Freedom Forever

COUNTY OF CONTRA COSTA

Job Address: 19 JAY CT, ALAMO, CA 94507

GROUND MOUNT SOLAR PERMIT PACKAGE BRUCE GINN 11.200KW DC GRID TIED PHOTOVOLTAIC SYSTEM 19 JAY CT, ALAMO, CA 94507		CODE INFORMATION THE INSTALLATION OF SOLAR ARRAYS AND PHOTOVOLTAIC POWER SYSTEMS SHALL COMPLY WITH THE FOLLOWING CODES: 2022 CALIFORNIA BUILDING CODE 2022 CALIFORNIA FIRE CODE 2022 CALIFORNIA PLUMBING CODE 2022 CALIFORNIA MECHANICAL CODE 2022 CALIFORNIA ENERGY CODE 2022 CALIFORNIA RESIDENTIAL CODE 2022 CALIFORNIA ADMINISTRATIVE CODE 2022 CALIFORNIA ELECTRICAL CODE AHJ: COUNTY OF CONTRA COSTA		REGISTERED PROFESSIONAL ENGINEER ALI HAJIHASHEMI C 84486 Ali Hajj Civil STATE OF CALIFORNIA EXP. 09/30/2023 5/8/2023 THESE DRAWINGS ARE SUBJECT TO COPYRIGHT PROTECTION BY US LAW. REPRODUCTION IN ANY FORM IS EXPRESSLY FORBIDDEN WITHOUT PRIOR WRITTEN APPROVAL FROM CURRENT RENEWABLES ENGINEERING INC. Current Renewables Engineering CURRENT RENEWABLES ENGINEERING INC. 1760 CHICAGO AVE SUITE J-13, RIVERSIDE CA 92507 PHONE: (951)-405-1733 WWW.CRENG.CO CONTRACTOR INFO freedom FOREVER GREG ALBRIGHT FREEDOM FOREVER CALIFORNIA, LLC 43445 BUSINESS PARK DR #110, TEMECULA, CA 92590 STATE OF CALIFORNIA C10 – ELECTR

TITLE
TREE PLAN

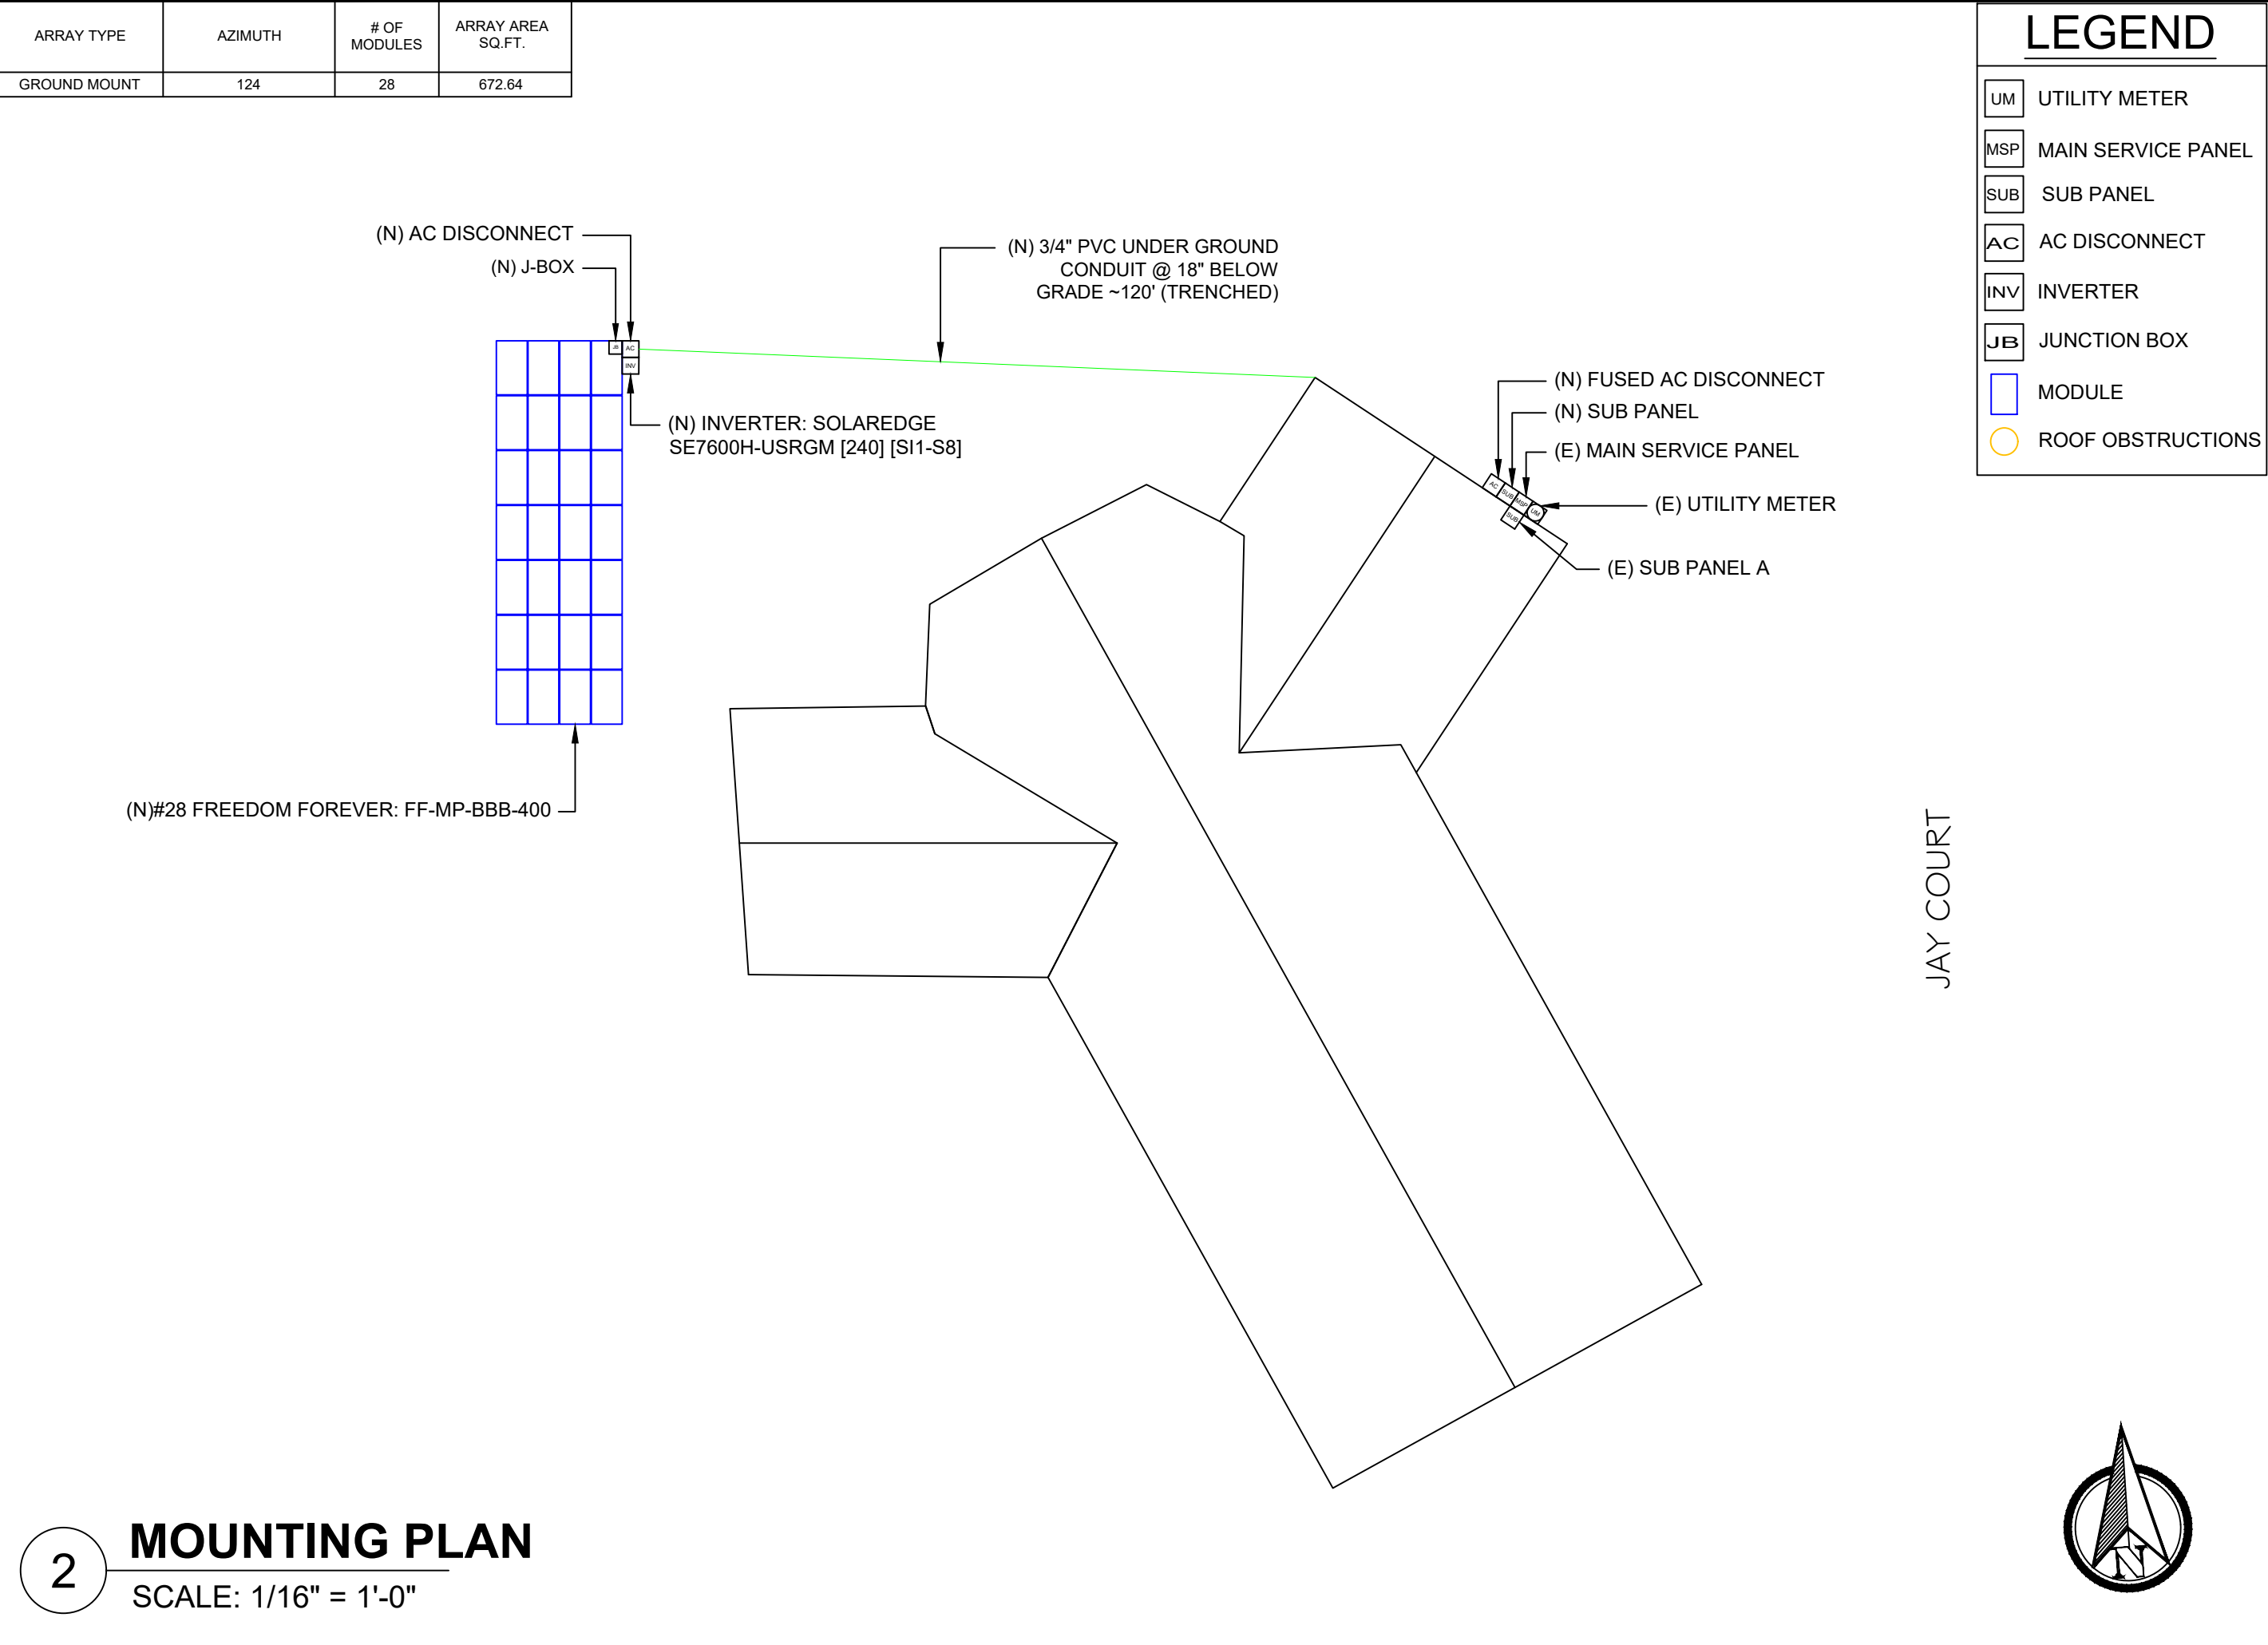
Trees removals will be done via climbing the trees. No crane or heavy machinery will be used.

TITLE
STRUCTURAL

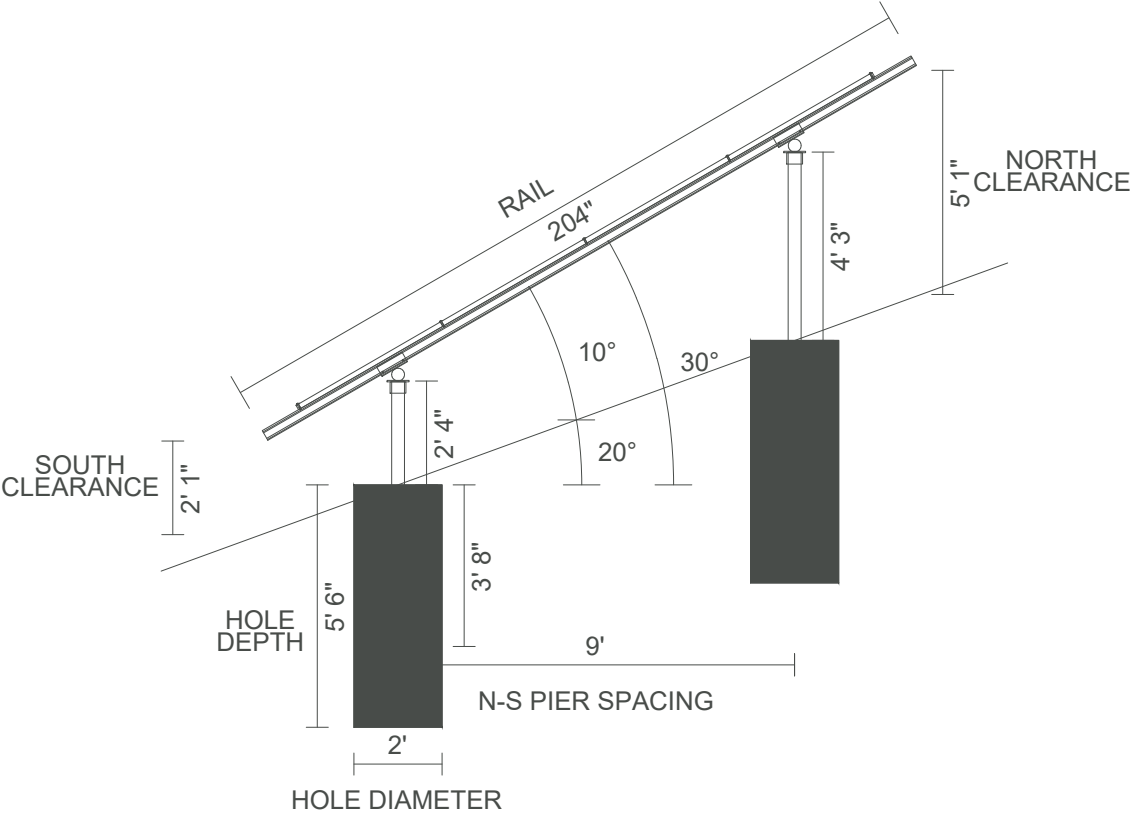
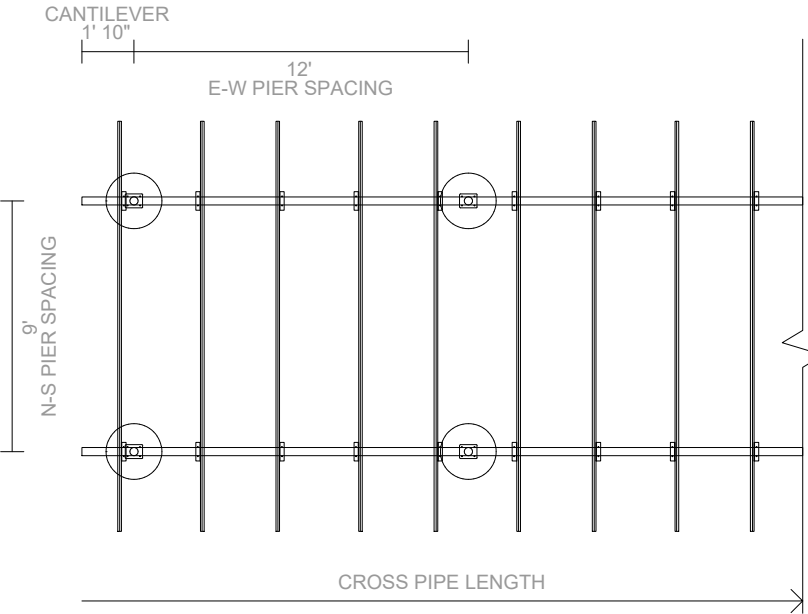
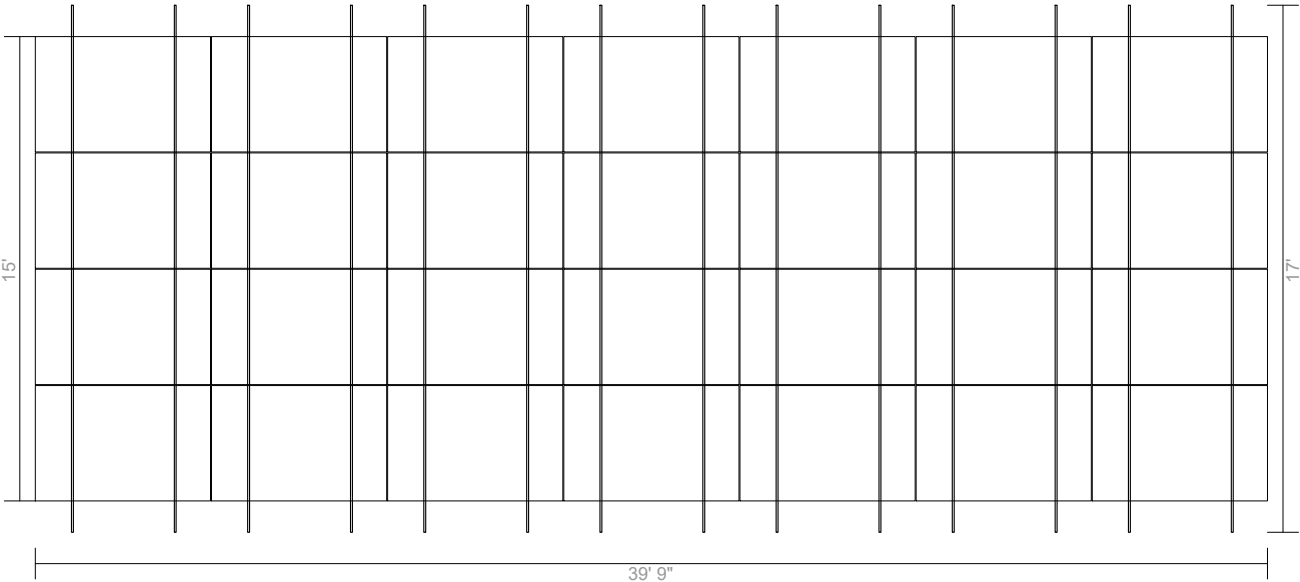
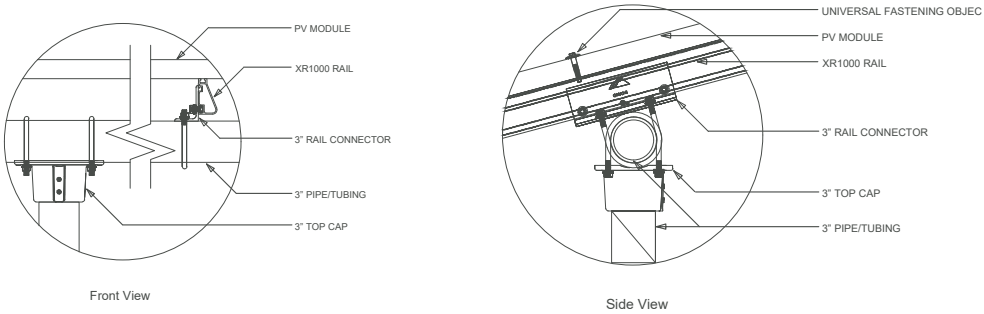
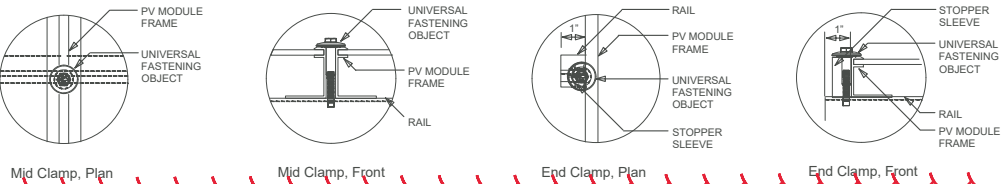
1. The BOM has been updated as per the requirement
2. ADD STRUCTURAL HAS BEEN UPDATED.
3. The report has been added.
